Subject: Cathode Wire Quality

1) [Tk003-4.jpg](#), downloaded 2353 times

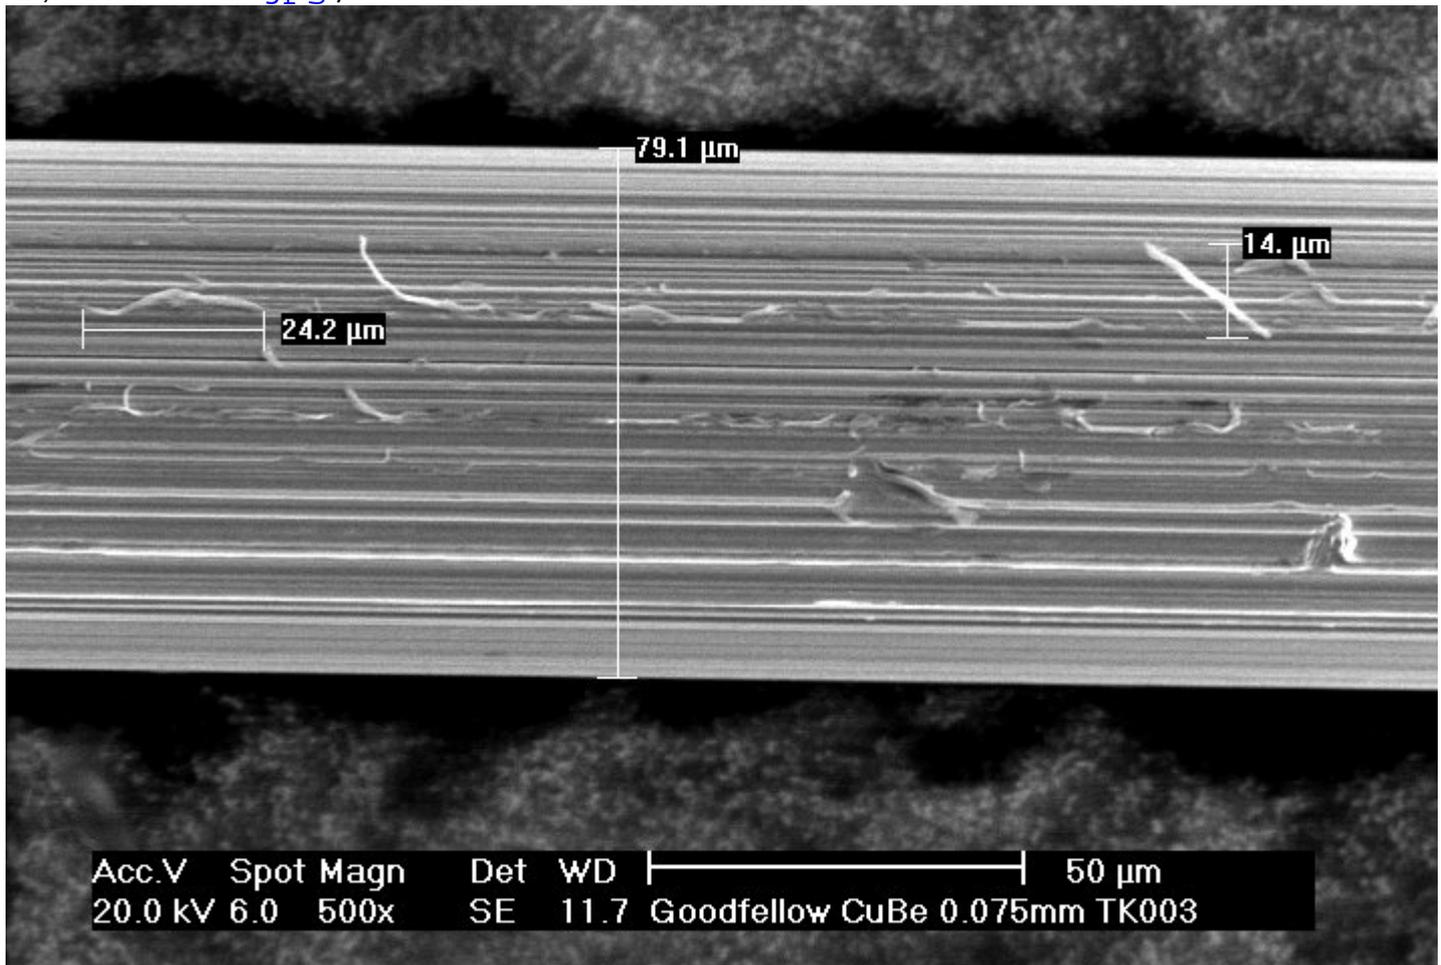
TK003: Some grooves are visible and pieces of metal sticking out, which is not nice. However, some people claim that one could live with a wire like that. The visible marks are probably due to an overused drawing die. Usually they are visible only on one side of the wire.
